PLAT COMMITTEE September 13, 2023

Case Number: 2023-PLT-011

Request: Approval of a Subdivision Plat, to be known as 3725 Kentucky Ave., dividing

2.11 acres into two lots.

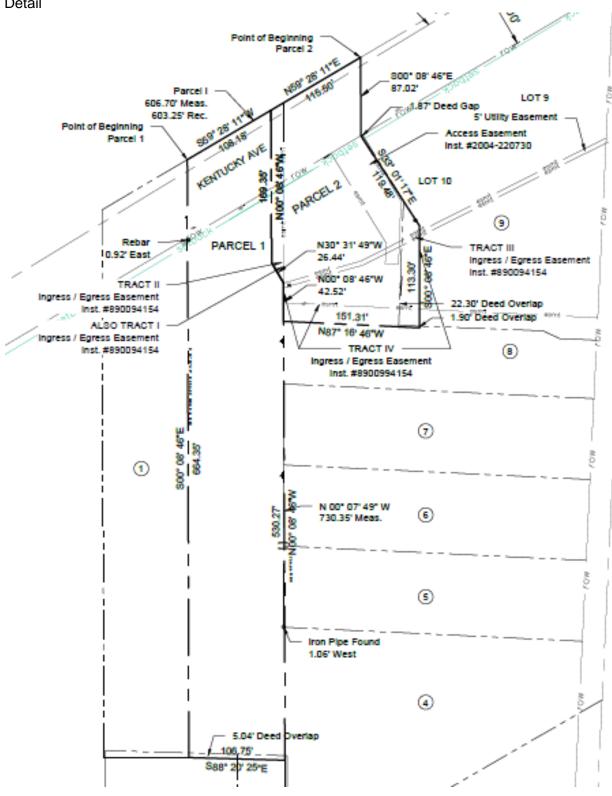
- 10. That the plat restrictions and covenants, done in accordance with the rezoning commitments, be submitted prior to recording the final plat.
- 11. That all the standards related to secondary plat approval listed in Sections 741-207 and 741-208 of the Consolidated Zoning and Subdivision Ordinance be met prior to recording the final plat.
- 12. That parcels One and Two be relabeled as Lots One and Two prior to recording.

This site is zoned C-1 and C-3 and developed with a commercial integrated center with accessory parking. The proposed plat would subdivide the property into two lots along the tenant separation. The proposed plat meets the standards of the C-1 and C-3 zoning classification.
